Value Engineering Study

**US 27 RECONSTRUCTION
FROM US 150 BYPASS IN STANFORD TO KY 34
LINCOLN AND GARRARD COUNTIES, KENTUCKY**

**ITEM NUMBER 7-196.00
VE STUDY NUMBER 201204**

Final Report

Directional Left-turn Median Design

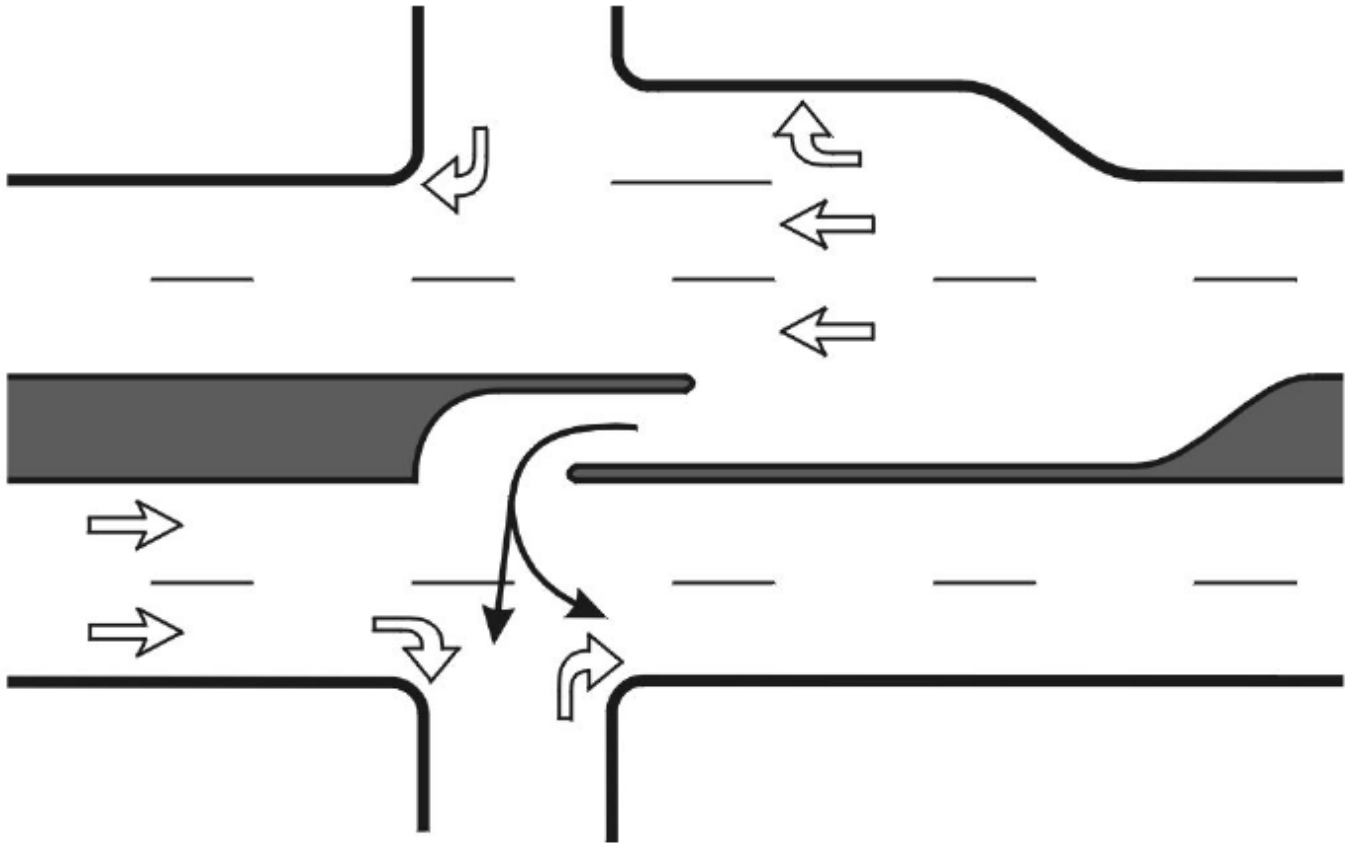
Develop an access management plan and memorandum of understand (MOU) for the corridor. Remove unnecessary and redundant connections to US 27, make all private driveway right-in/right-out access, and create strategic U-turn locations along the corridor.

First, it is recommended that an access management plan be created for the entire corridor. This plan would locate current and potential future access points, access design, intersection designs and signal locations, median openings and median opening design. To help ensure that the plan is carried out, KYTC should enter into a MOU with the counties' and cities' governments that adopts the plan and outlines the procedure to agree on future modifications to the plan.

1. To protect this corridor for the travelling public long term, it is recommended that all redundant and unnecessary access be removed. In locations where access is provided on each side to serve a parcel that was severed, the design team should consider installing a culvert so the conflict points and potential pressure for signals are eliminated.

3. Full median openings (or alternative designs such as superstreet) should only be located at high volume intersections such KY 52 and old US 27. All other access locations should be right-in/right-out with median control or have a directional median opening design that allows left turns into but no through or lefts from the access.

Diagram of Superstreet Concept (Alternative 1)

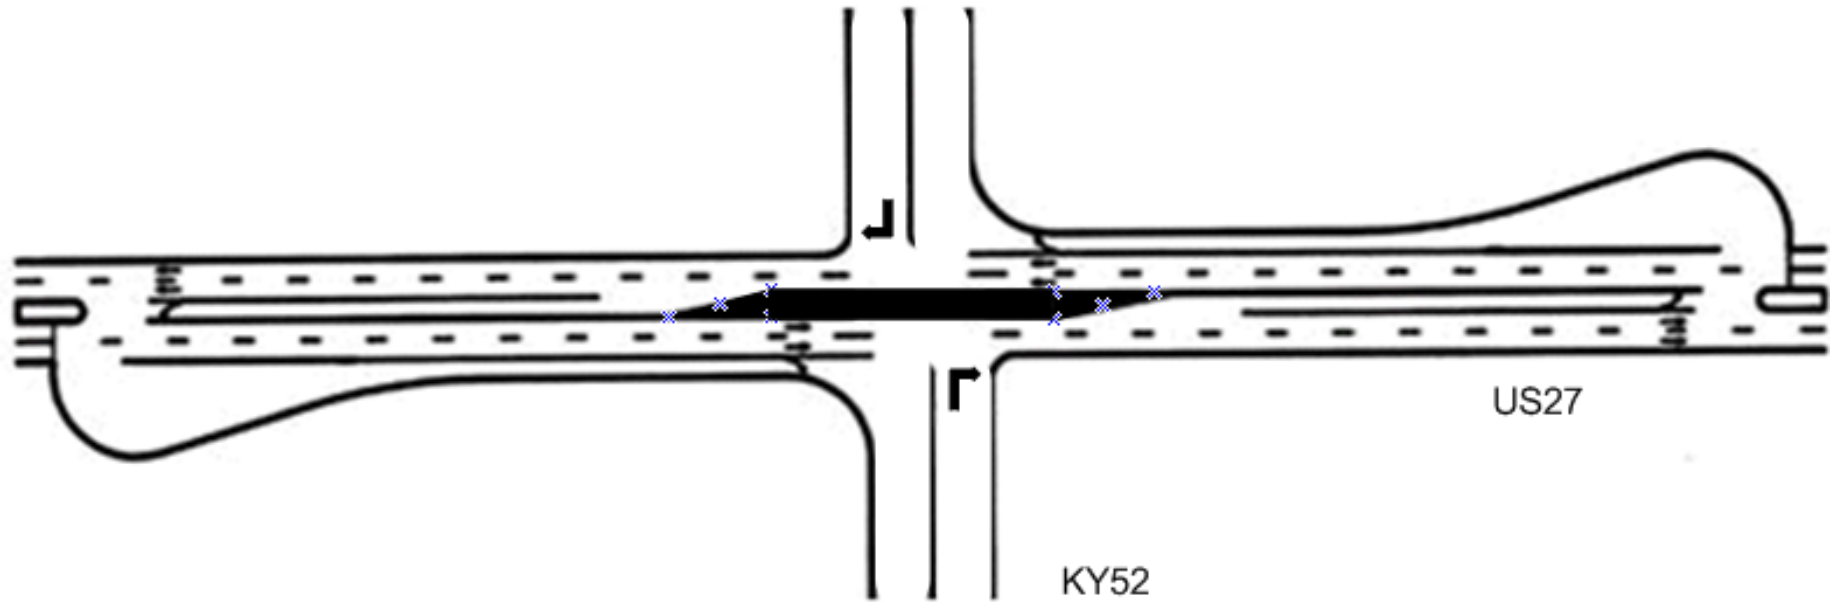
Utilize a superstreet intersection in lieu of a standard intersection at US 27 and KY 52.

The original design specifies a standard, signalized intersection, with the assumption that a traffic signal will be warranted.

The VE Team recommends re-evaluating the intersection design and constructing a superstreet design.

There are two alternatives to the superstreet design that should be considered. The first is where all movements from KY 52 and left turns from US 27 are achieved indirectly through accessing a median u-turn past the intersection. The second is where movements from KY 52 are achieved indirectly through accessing a median u-turn past the intersection; left turns are permitted at the intersection. The first would be preferred due to its simplicity and better operation on mainline US 27.

Recommended Design: Complete Street with Raised Median, Bicycle Lanes, and Sidewalks

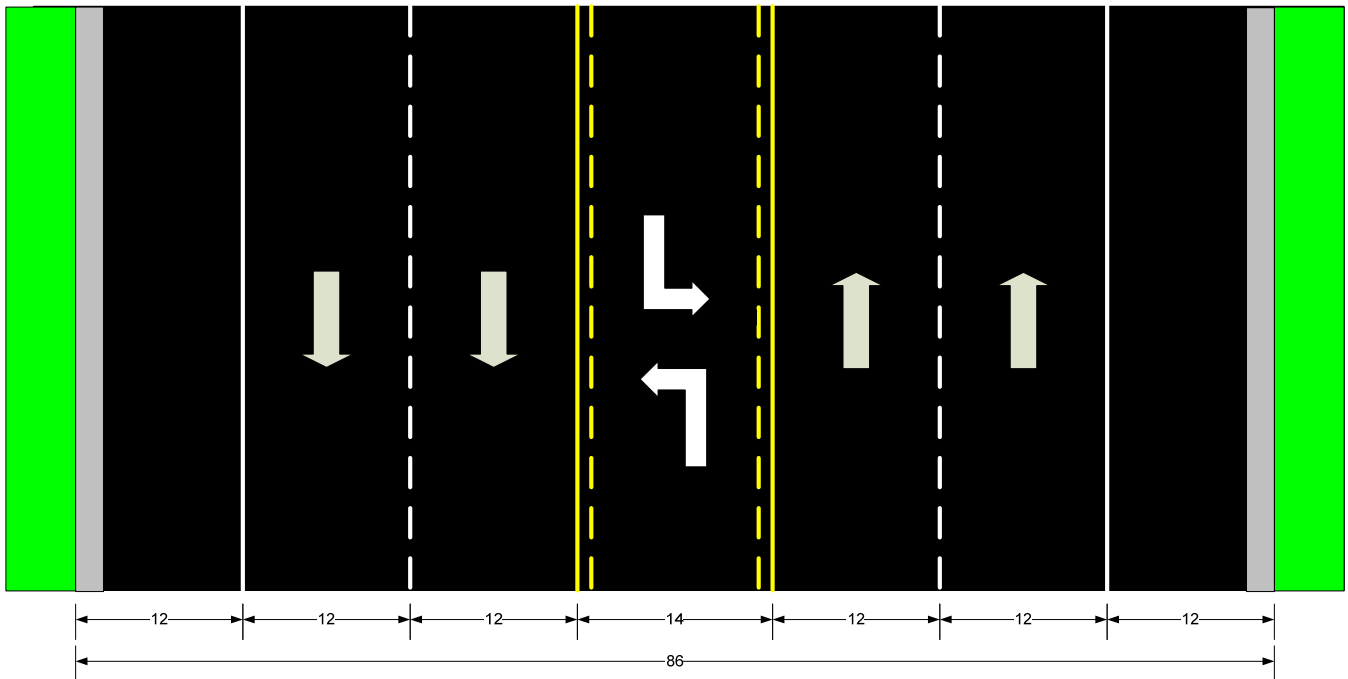
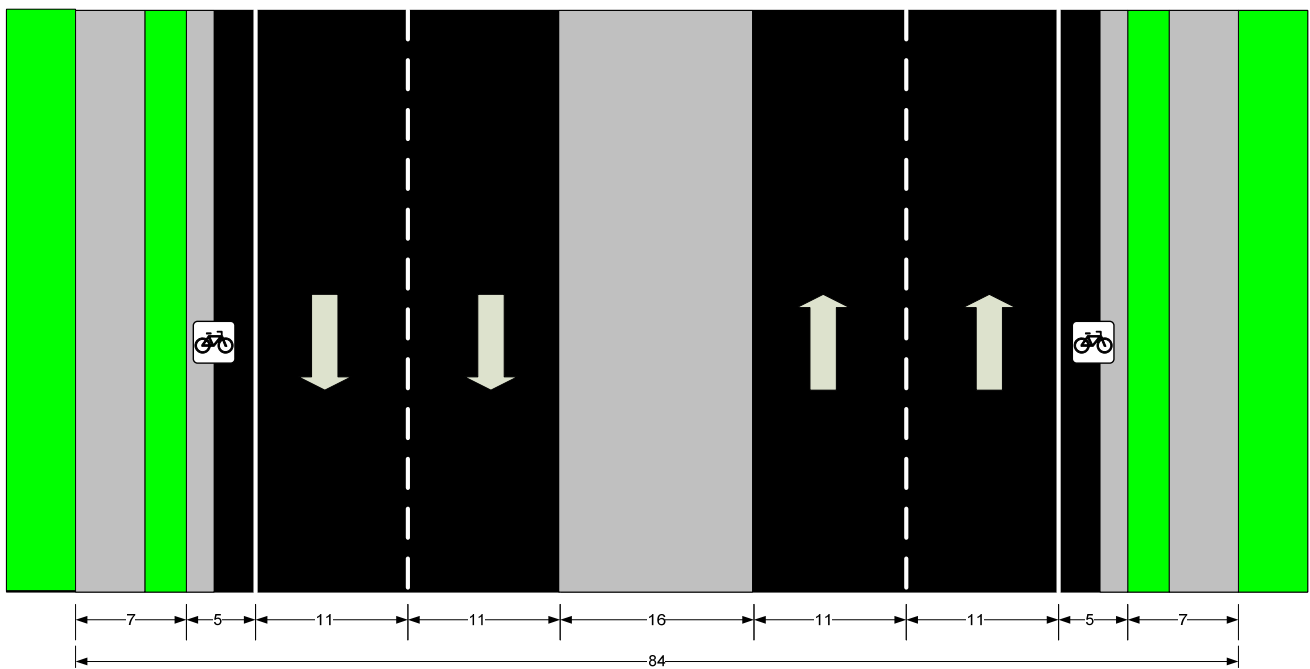
RECOMMENDED CHANGE:

- Better supports the urban context
- Supports non-motorized travel
- Helps control access (vehicular and pedestrian safety) by limiting turning movements and minimizing conflict points
- Fits approximately within planned ROW limits

Cap and Column Pier

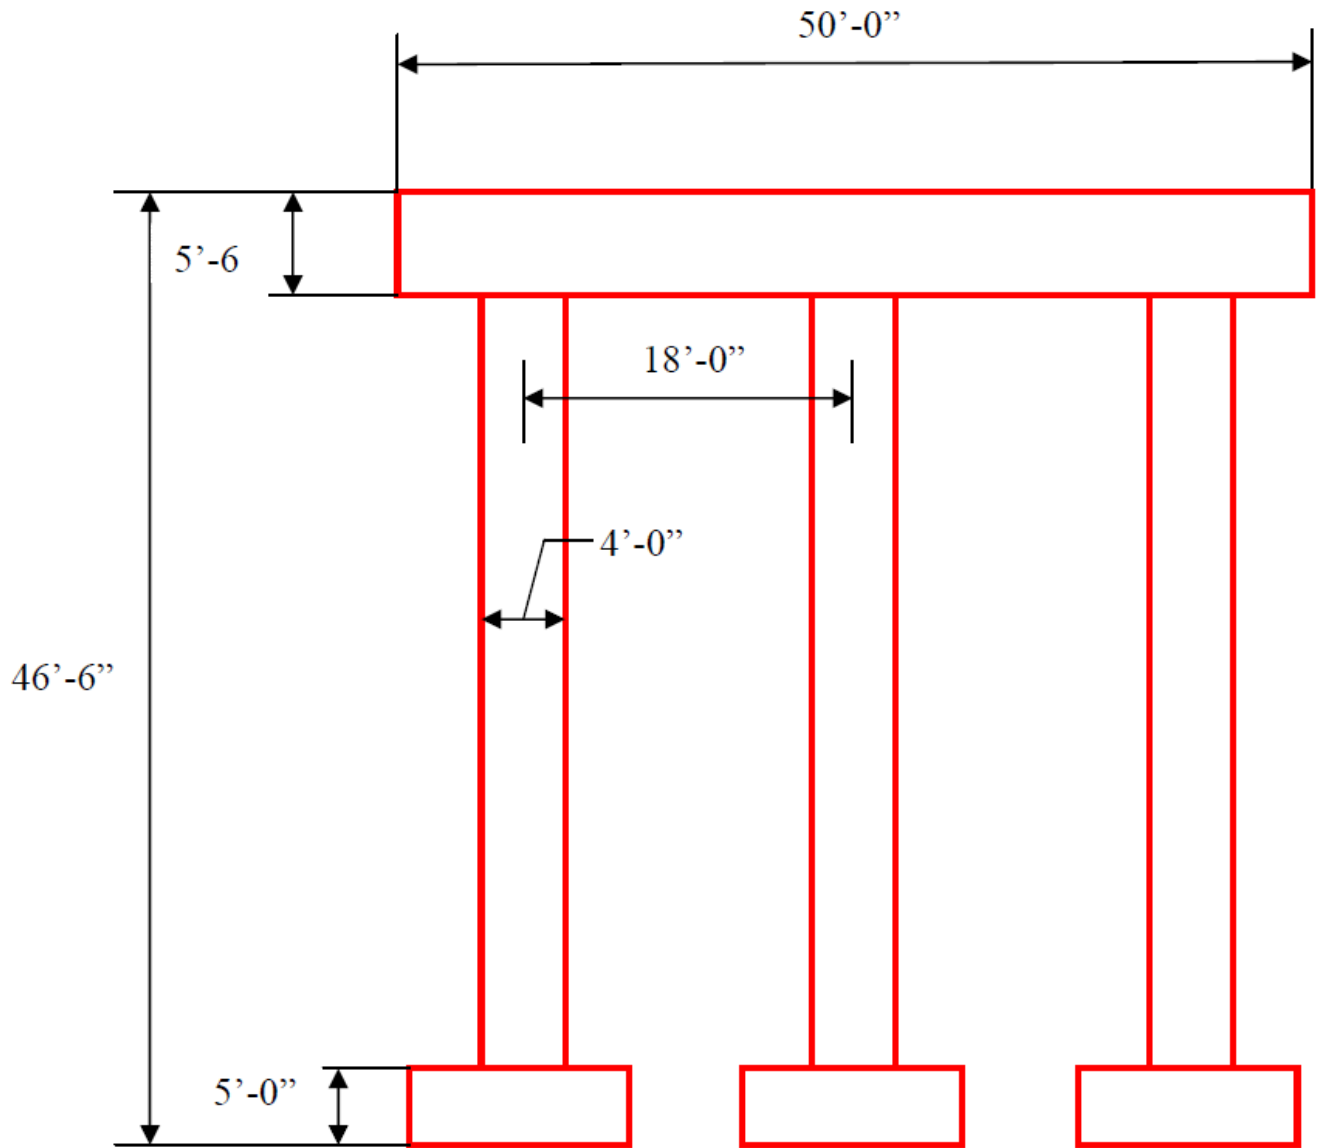
Utilizing a substructure of this type will save on material costs and will be easier to form than a hammerhead pier. The piers are not located within the river normal flow line, therefore debris collection on this pier type should not be a concern. Also, as the piers are located outside of the normal flow, spread footings on rock are acceptable as scour should not be a concern. The recommended change will have equal function and utility as the original design. Hammerhead piers of similar height have been valued engineered to cap and columns by the contractor during construction.

SKETCH OF RECOMMENDED DESIGN

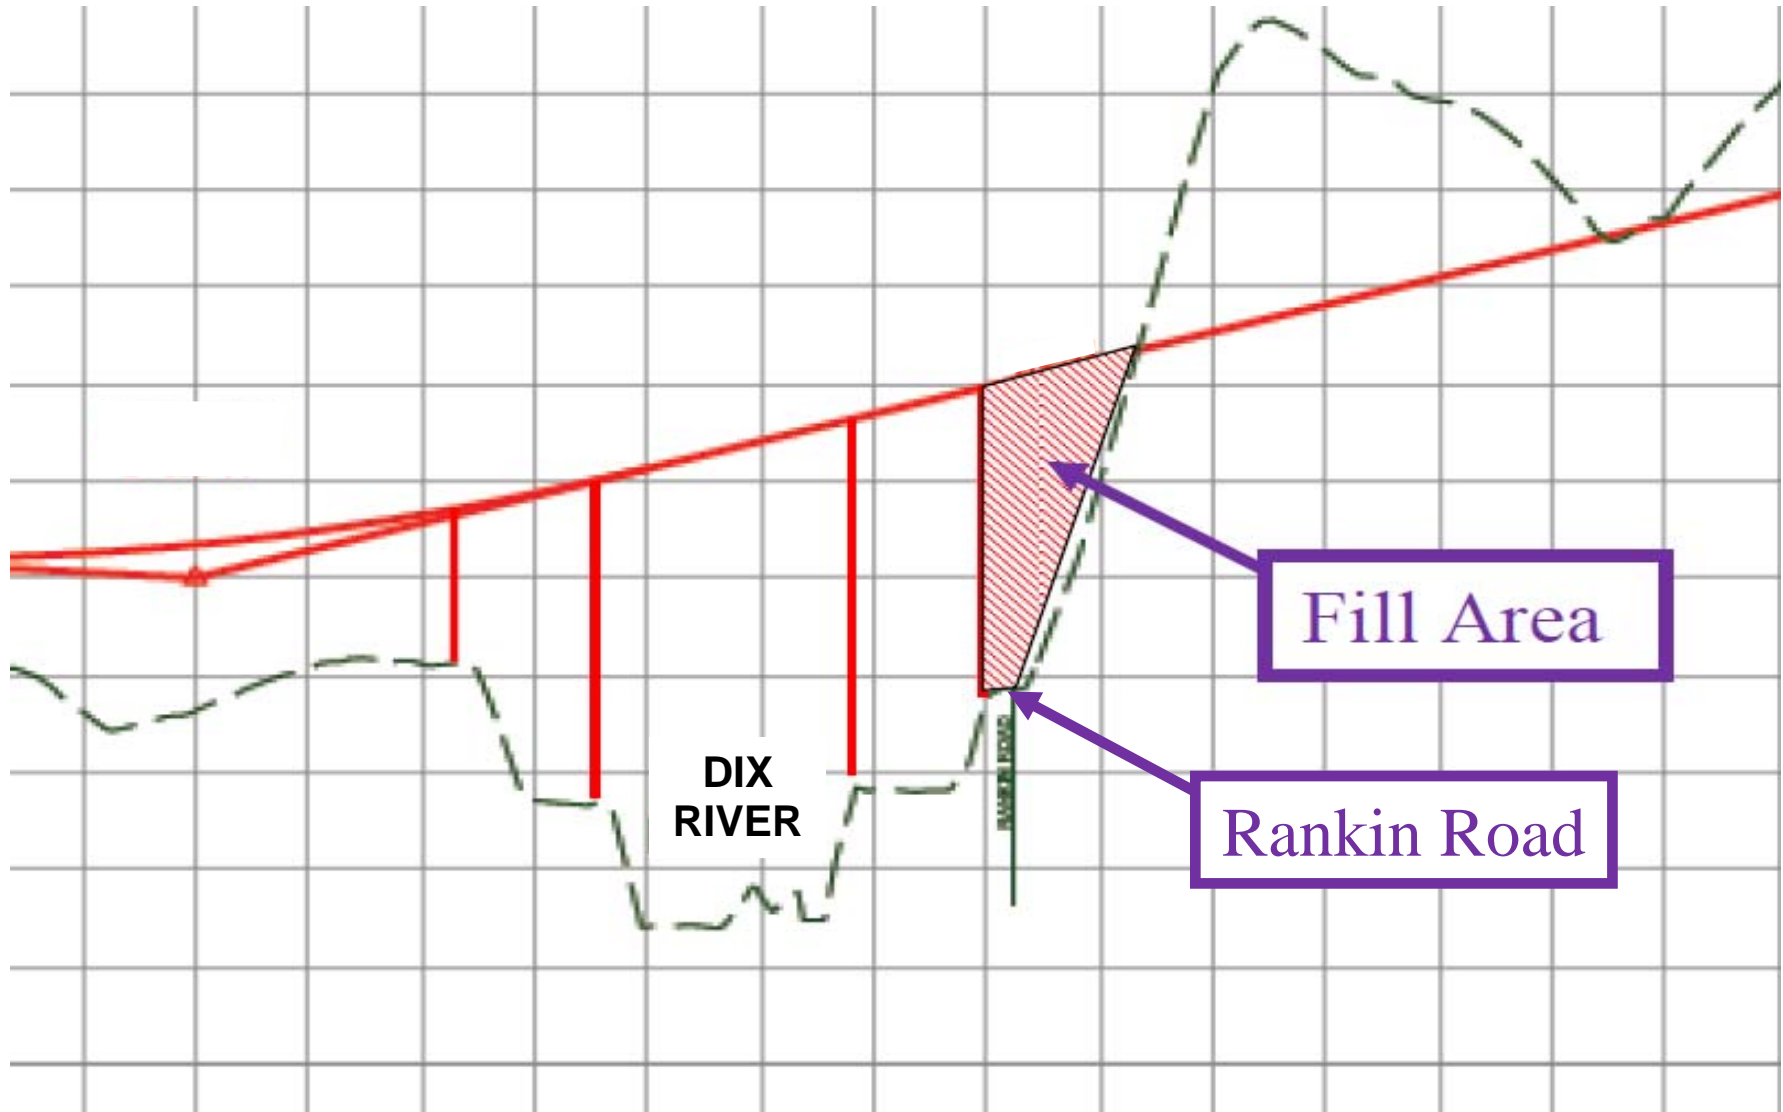
The VE Team recommends eliminating the span over Rankin Road. Eliminating this span would split Rankin Road into a west and an east section. The fill area under the bridge would have little direct effect to the properties in the area. Access to US 27 is maintained by an existing connection to the West. The recommended change would result in a total span length of approximately 560 feet.

SKETCH OF RECOMMENDED DESIGN

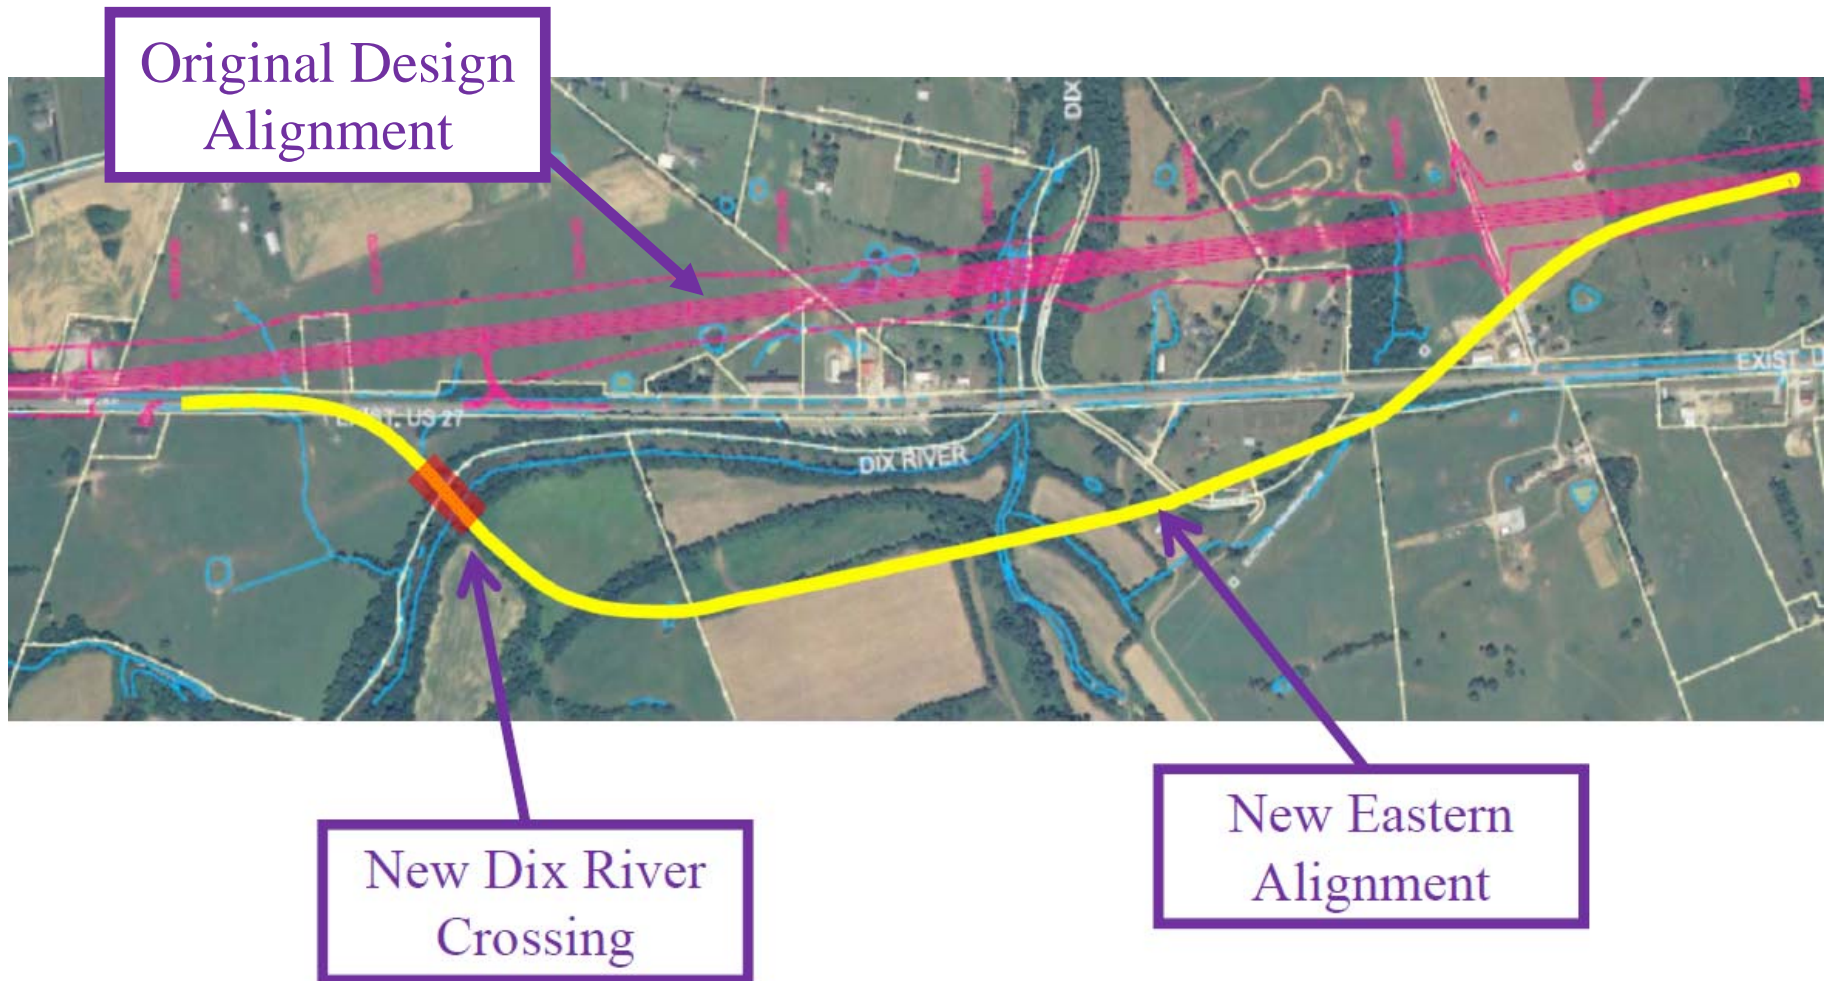
Shift the Dix River crossing to the east of existing alignment to provide a shorter, 90-degree structure in lieu of a skewed structure.
